# BECI Field Report

**Perdido Sun**  
13753 Perdido Key Dr.  
Pensacola, FL 32507

FIELD REPORT NO: **PRDDSN017**

**FIGURE 1 - View of new EFCO storefront windows installed at north elevation above Porte cochere.**

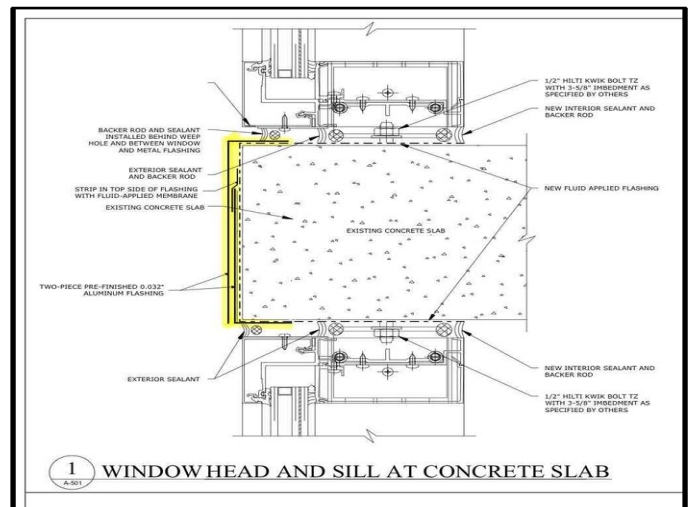
- 17.2 BECI, C/Sharpe, and Perdido Sun Representatives met on-site to review the completed slab edge flashing mock-up installed between the new storefront windows at the north elevation above the Porte cochere (Reference Figure 1). The new two-piece metal flashing was installed between the concrete slabs and the EFCO storefront windows, following BECI's Detail 1/A-501 and field directives from Report No. 14 (Reference Figure 2). The goal was for the flashing to sit flush with the window systems; however, due to varying conditions of the concrete slabs, there were some areas where the flashing jutted out slightly. Despite these minor variations, the flashing still performs as intended from both a technical and waterproofing standpoint, ensuring no issues with the building's protection against the elements. BECI reviewed the mock-up both during and after installation, confirming the flashing was installed as planned, met all technical requirements, and was adjusted when directed by BECI. The purpose of meeting with Perdido Sun representative Curtis was to review the mock-up and ensure it met the project's aesthetic goals. After inspecting the installation, Curtis approved the look, agreeing that the design met the visual standards. With this approval, Action Item No. 14.2.1 will be marked as completed.
